SERVICE BULLETIN AMATEUR RADIO

SUBJECTTH-205/215 PROTECTION FUSE REPLACEMENT

7/22/87

DC Plug specifications

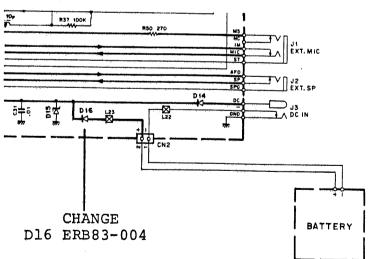
When a plug other than the PG-2V or PG-3C type is inserted into the DC IN jack, the ground side of the jack may not disconnect. This may cause the external DC power to be supplied directly to the internal battery which results in overheating the battery and blowing the fuse. To protect the battery, replace the fuse with a protection diode (Part # ERB83-004).

NOTE: Models with serial numbers greater than 801xxxx already incorporate the diode as D16.
